**IN THE DRAWINGS:**

## **REMARKS**

### **ITEM 1: OBJECTION TO THE DRAWINGS**

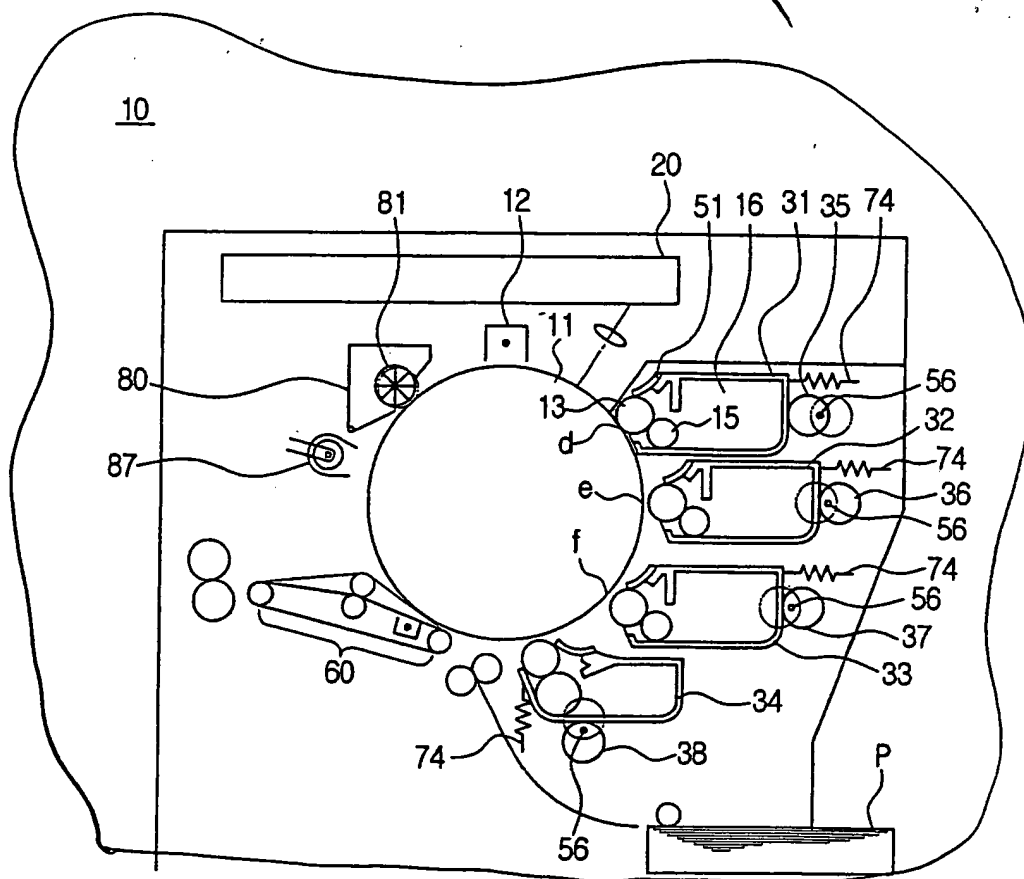
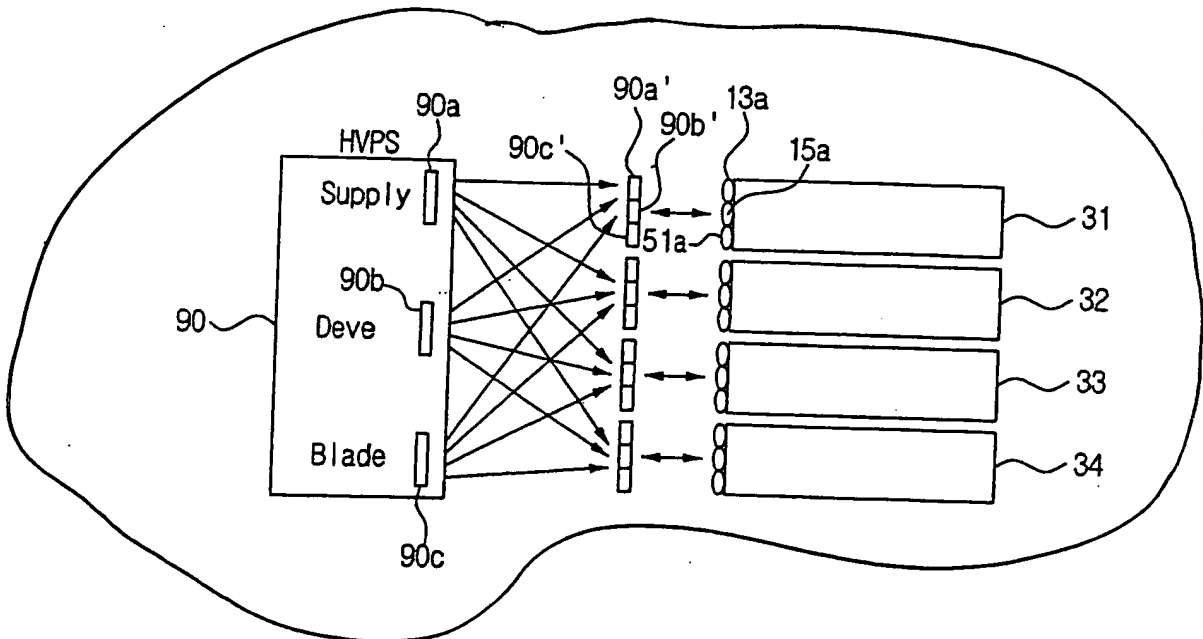
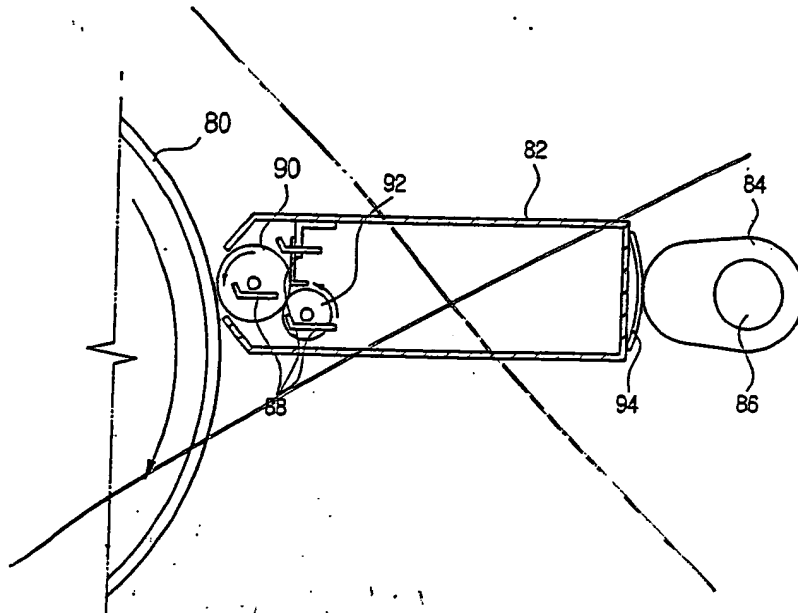
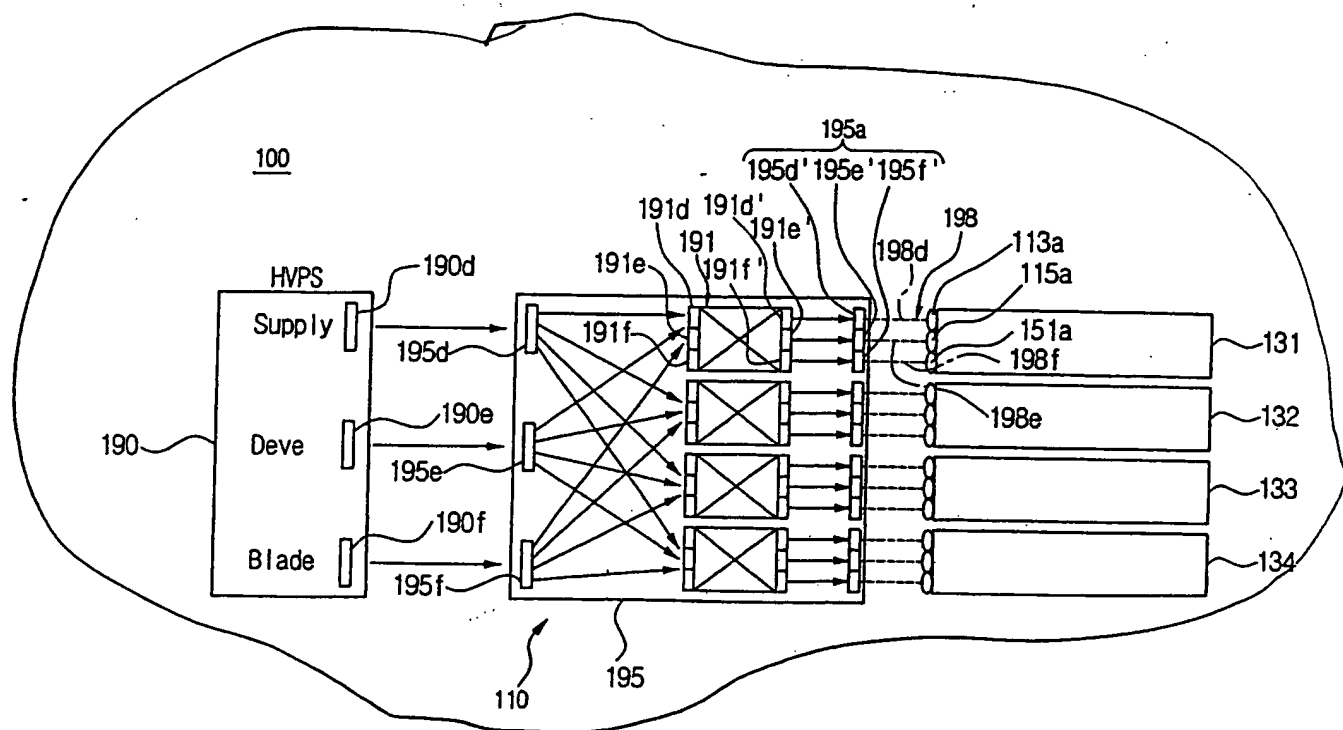
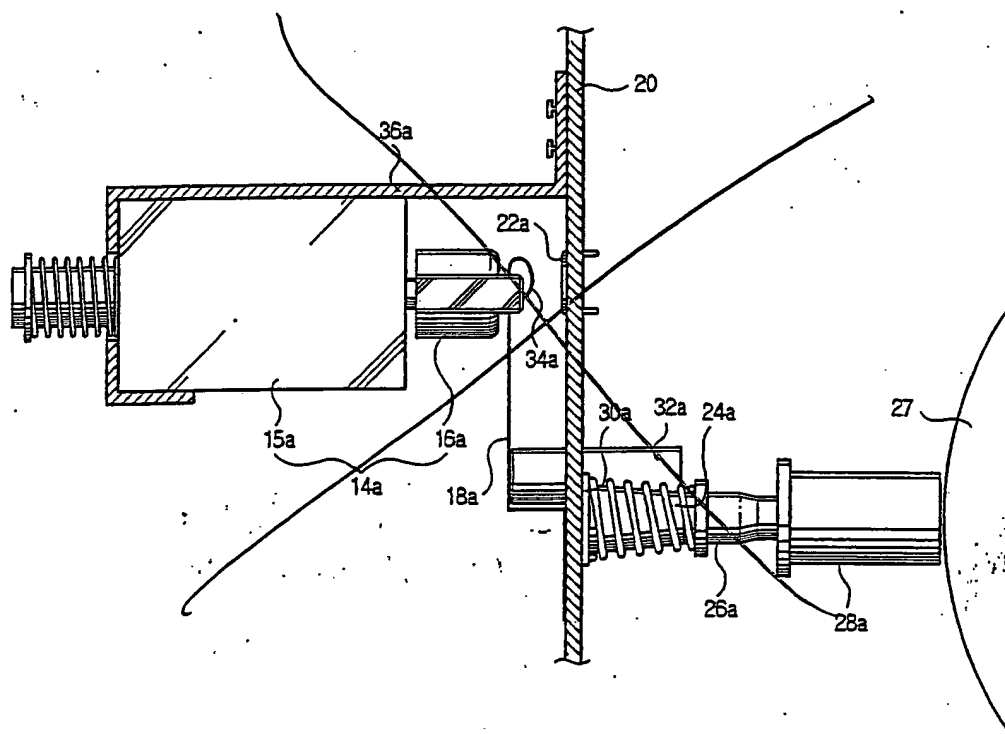
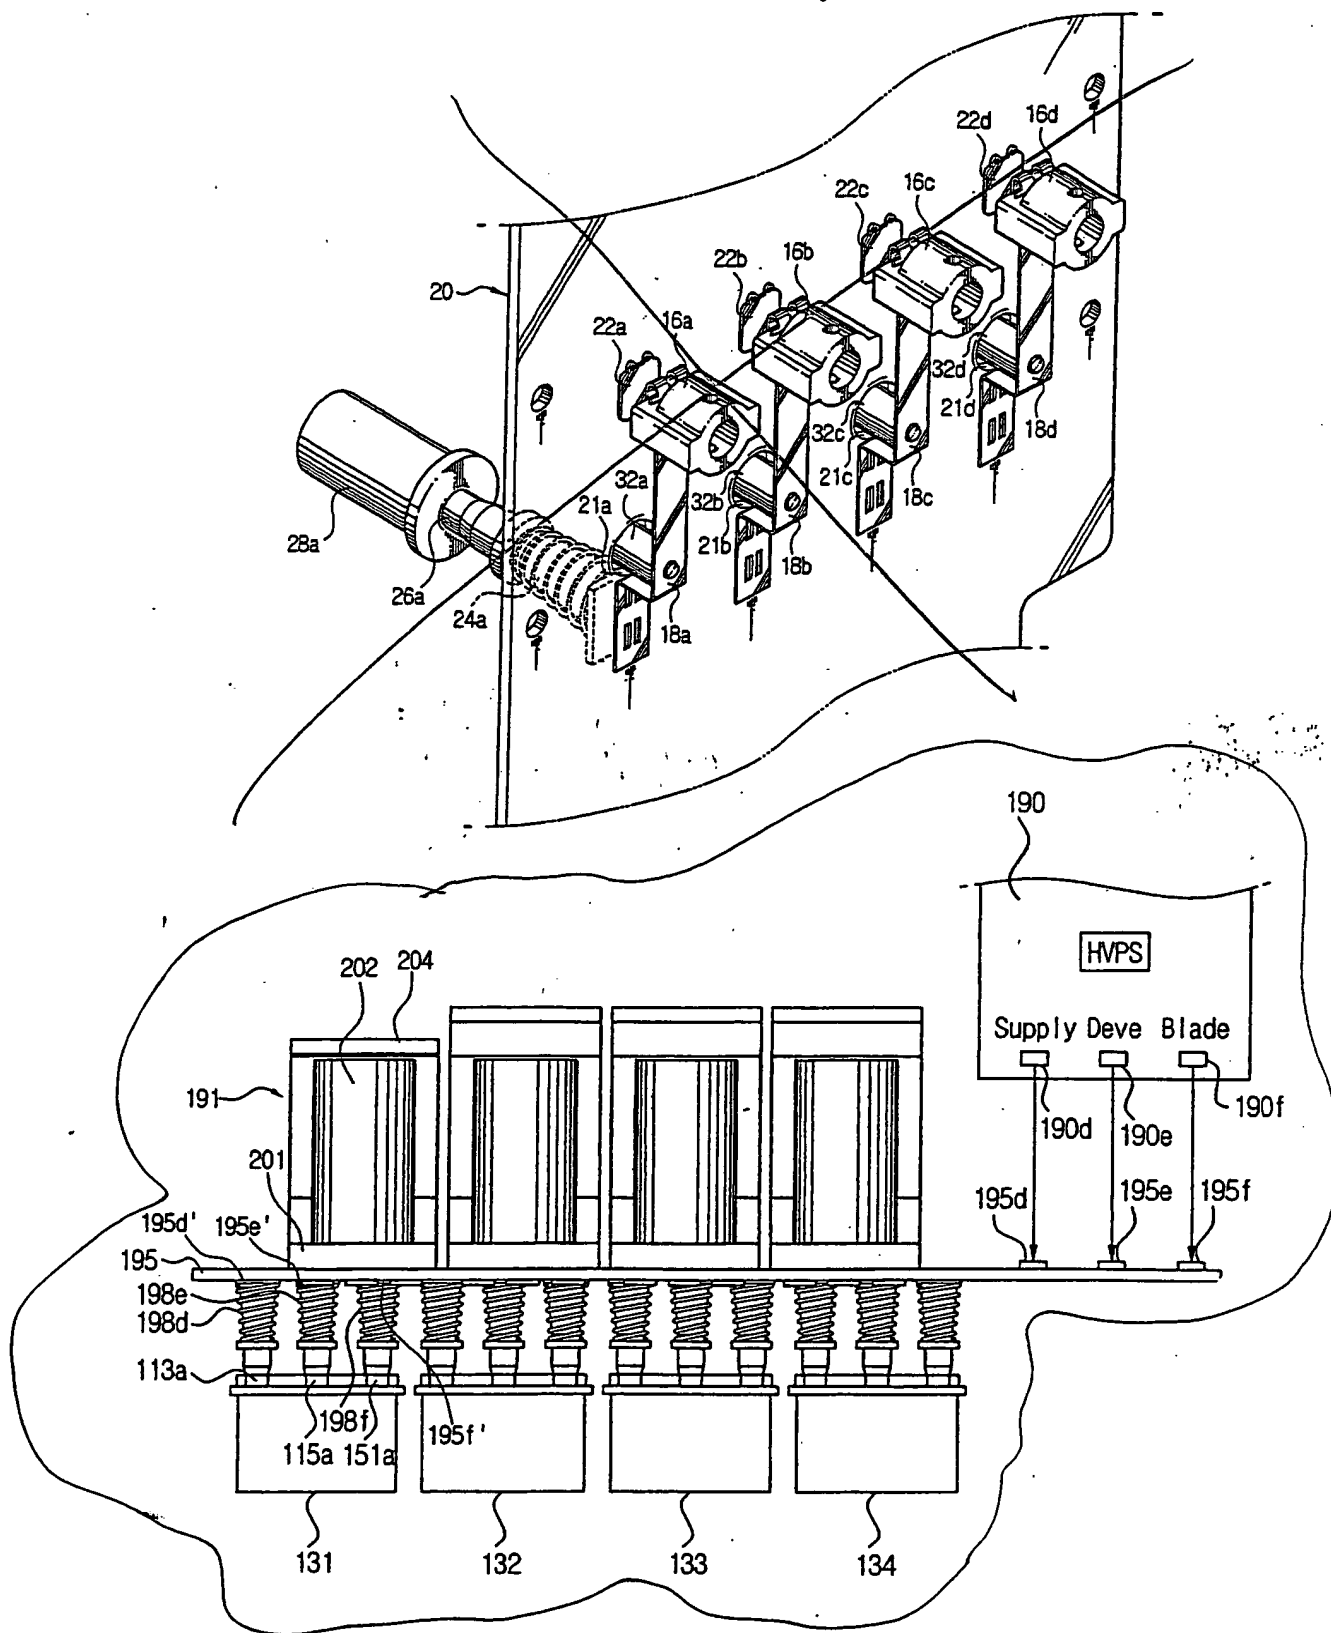
In the Office Action at item 1, the Examiner objected to the drawings in that they failed to match up to the reference parts as described in the specification. In order to overcome this objections, replacement figures are submitted herewith. Replacement FIGs. 1, 2, 3, 4, and 5 correspond to the reference parts as described in the specification.

In item 1, the Examiner objects to the drawings under 37 CFR 1.83(a) because they fail to match up with reference parts as described in the specification. FIGS. 1-5 are amended herein to provide drawings that provide views that match up to the reference parts as described in the specification. See, for example, paragraphs [0003]-[0018] and paragraphs [0050]-[0070].

The attached drawing(s) include changes to FIGS. 1, 2, 3, 4, and 5. The sheets containing FIGs. 1, 2, 3, 4, and 5 replace the respective original sheets including FIGs. 1, 2, 3, 4, and 5.
